MVE Freezer Number Labels

Discharge Device Relief Valves

MODEL: MVE Manual Liquid Discharge Devices

Manual Discharge Device Service Relief Valves

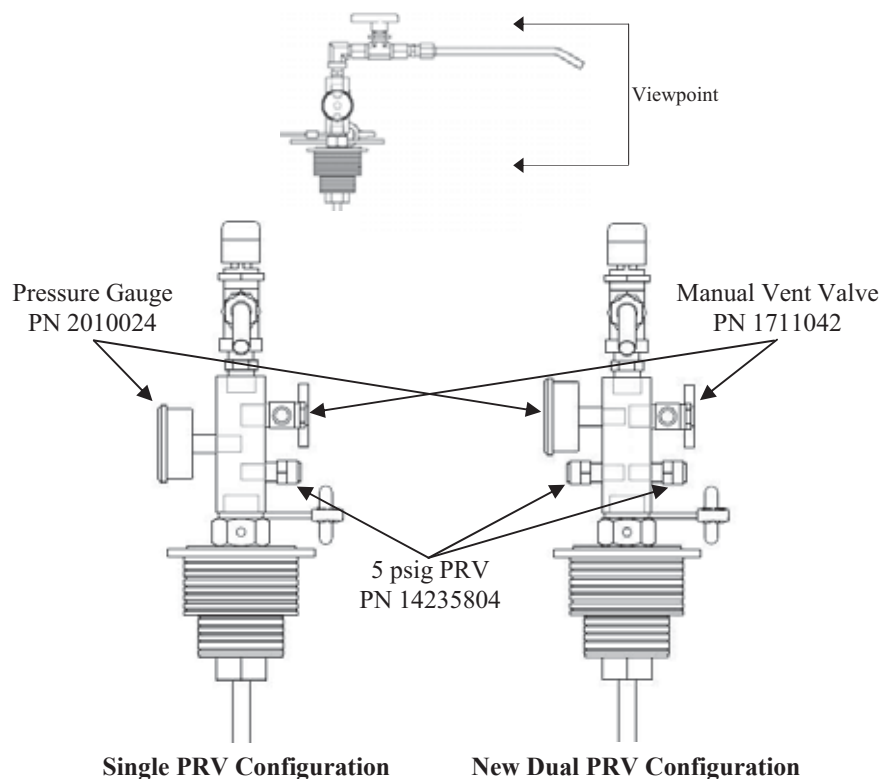
DETAILS: In May 2009, all MVE manual liquid discharge devices will undergo a design change and will be equipped with a second 5 psig (0,34 bar) primary relief valve (PRV). To accommodate this redundant PRV, the pressure gauge is being shifted up directly across from the manual vent valve. This design enhancement will increase the volume of possible relief valve flow. The second relief valve will have the same threads and pressure rating as the current one; however, the part number for the discharge device relief valves will change. Both designs will use the same service relief valves.

Manual Discharge Device	Previous Part Number	New Part Number
Single relief valve design	1810112	14235804
Dual relief valve design	N/A	14235804 x 2
